# Victoria Quarter

**Save New Barnet**

**Response to Planning Application 21/3676/FUL**

**August 2021**

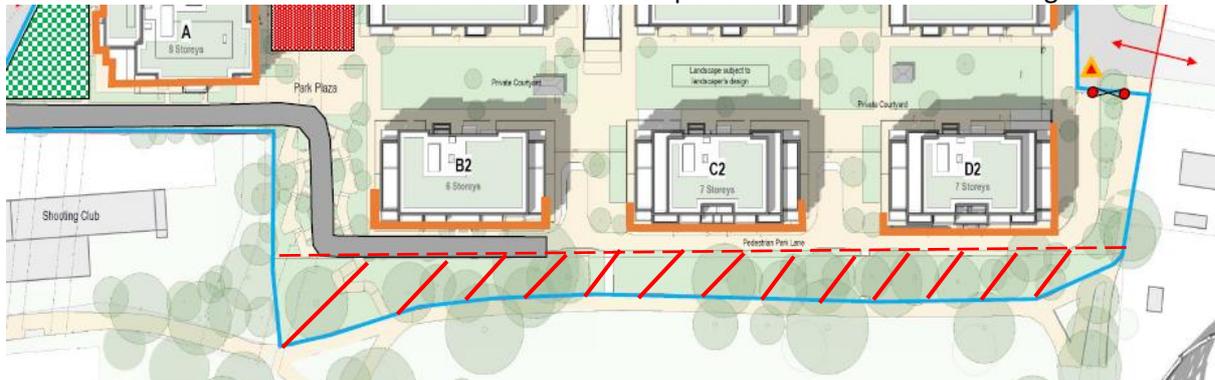
We are very concerned that the basis for calculating the public amenity space is flawed. This stems from the fact that the application site is larger than the ownership site and includes a strip of land approximately 1,680sqm within Victoria Recreation Ground, as illustrated on the applicant’s document “Proposed Site Location Plan”. If this strip of land has been included in the calculation of public amenity space, then it provides a false statement of the actual amenity space.

In addition, we are very concerned that the applicant will deprive the local community of approximately 1,680 sqm of Victoria recreation ground for the 5 year period of construction as they propose to erect hoarding immediately adjacent to the footpath enclosing all of the trees and the grassed area behind the hoarding. This can be illustrated on the applicant’s site set up plan set out below where the red dotted line indicates ownership and the blue line the hoarding line:

This also raises very serious concerns about the health of the trees, the risk of damage and lack of care and maintenance during the five year period. Given that the applicant does not own this land we do not see how they can lawfully enclose it for the duration of the construction period.

We also note that the footpath and footbridge leading under the railway line will be within the hoarded boundary. This path is a public right of way as set out in the Definite Map of Barnet's public rights of way. Temporary closure is acceptable while development works take place but the closure of this right of way may last 5 years. No details have been provided on how this right of way will be maintained or reconstructed following demolition of the walkway, something that was raised by the GLA in their pre-application advice but which the applicant has failed to address.

Blocks E, F1,2 &3, F4, and G - Facing the Railway Embankment and Spine Road –  
**Yellow line indicates non opening windows.**

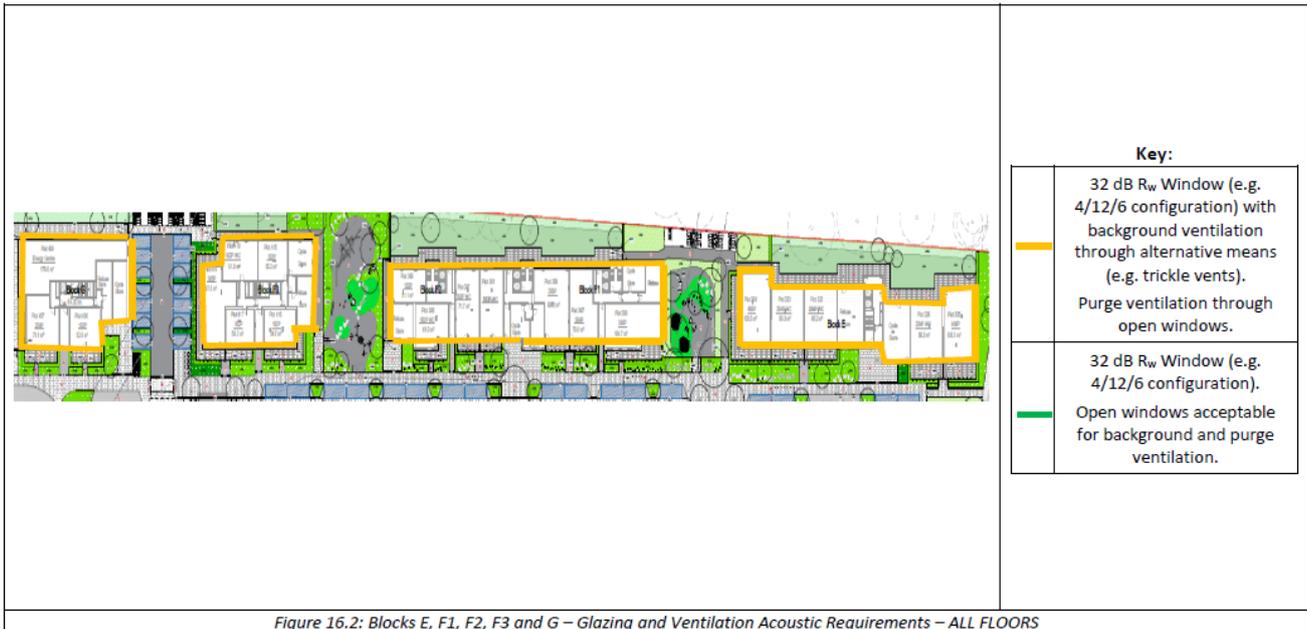
We would note that the approved methodology for measuring train noise DoT CRN 1997 states that measurement should be taken 1 metre and 4 metres above track level. Nevertheless, the conclusion of the noise report is that the flats in blocks facing the railway line will be so affected by noise that the windows should remain closed. This is reinforced in the Energy report which states that windows **cannot** be opened for purge ventilation.

Considering the height of the embankment and the height of the blocks which face the embankment, taking sound readings at 4.5m-9 metres (which appears to be the height difference between the ground and the top of the embankment) would have given a more realistic perspective of the noise experienced by flats especially in floors 4,5,6 & 7.

Set out overleaf are the noise standards recommendations in the affected blocks which make it clear the noise levels are too high to allow for opening windows in those flats facing the railway embankment or the Spine Road. In addition, paragraph 7.5 which states:

***“For the units facing the Railway and Victoria Road the acoustic assessments have identified that windows along these elevation must remain closed during day time and night time and therefore cannot be relied upon to provide purge ventilation for mitigating excess heat”.***

The design of the scheme has created such serious noise issues that hundreds of the flats will be required to have non opening windows. This could have been overcome in all of the blocks, other than those facing Victoria Road, with better design, something the Save New Barnet campaign team shared with the applicant and their architects. As such, this scheme is in breach of London Plan Policy D14.

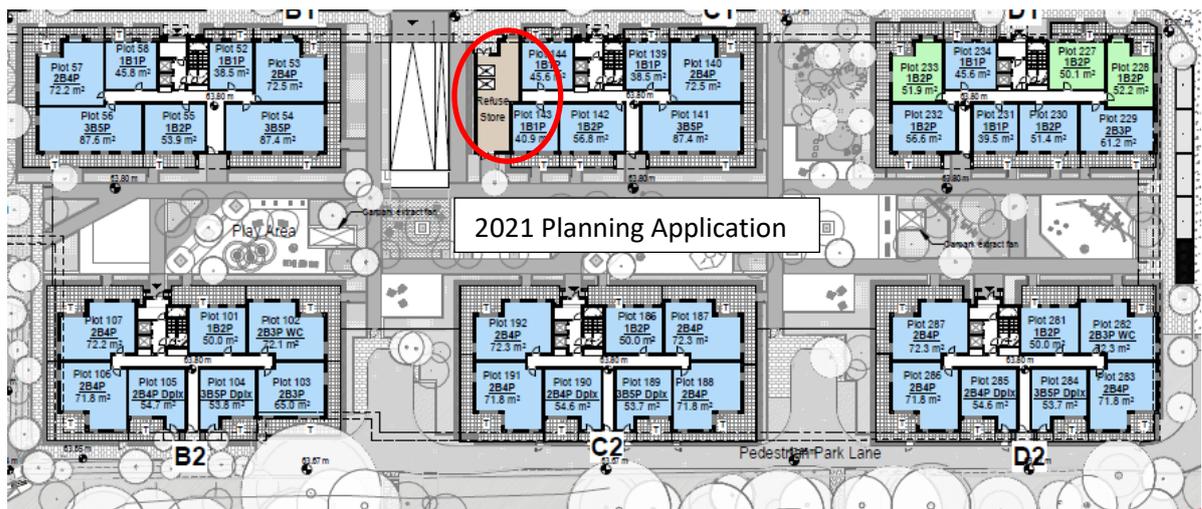
In the 2020 scheme, Blocks B1, B2, C1, C2, D1 & D2 all had surface level refuse stores in close proximity to refuse collection points.

However, in the proposed scheme these bin stores have now been moved to the basement car park with one small surface level refuse store in Block C1.

The consequence of this major design change is that residents of these 6 blocks will now have to go to the basement to drop off their rubbish, something which may be off putting to some tenants. However, these basement bin stores only have capacity for three days storage so in

Basement Level Bin Stores:

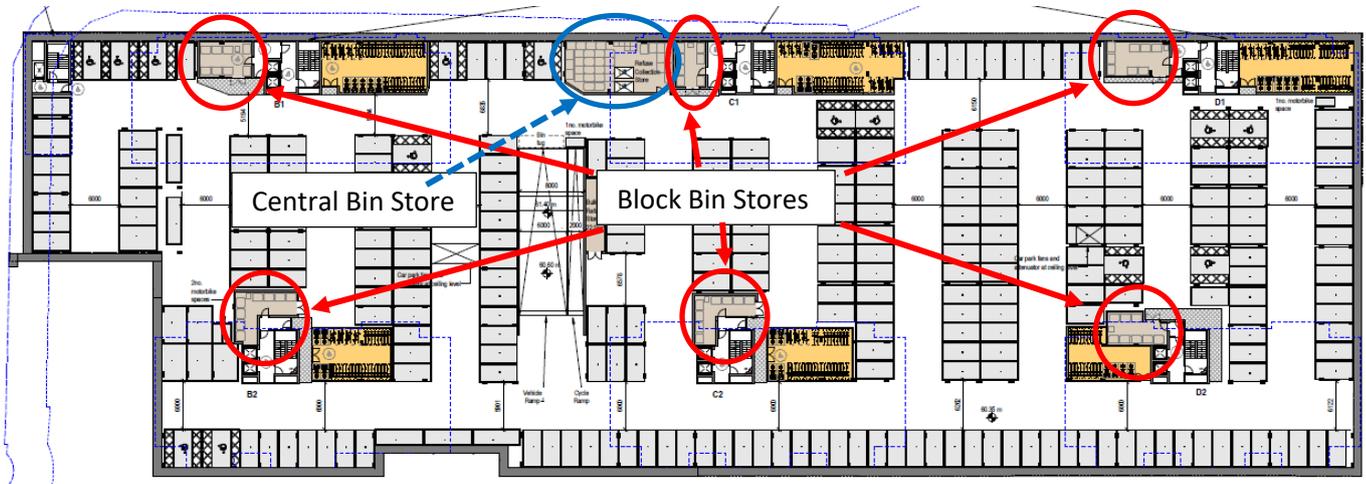
As a result, the building management team will have to regularly monitor the bins within the individual core bin stores (ringed in red) and once the bins get full, they will have to replace these with an empty bin from the central basement bin store (ringed in blue). In order to transfer bins from the core bin stores, to the central bin store, the building management team will use electric tugs.

On the day of collection, which in New Barnet is currently Mondays for both general and recycled waste, the building management team will have to move the bins via service lifts to the ground floor waste and recycling holding room from where the refuse collection staff will wheel these bins to the refuse collection point. The problem is that the bin store at ground level is very small and certainly unable to accommodate anywhere near the forecast 78 commercial size 1,100 litre bins that will need to be collected on the same day. As a result, it is likely that they will have to be positioned along the narrow pavement and possibly in the road, something which is both bad for pedestrians and will make the site look unsightly on bin collection days. After the bins have been emptied, the building management team will then need to move all of the empty bins back down to the basement and split them between the six core bins stores and the central bin store.

Critically, the level of management required to monitor the basement bin capacities, to move bins between the central bin store and the core bin stores and vice versa and to move the 78 bins to ground level and back down again on collection day will be very significant and expensive. This complexity has been designed into the scheme in the latest application as it did not exist in the 2020 scheme when the bin stores were all at ground level.
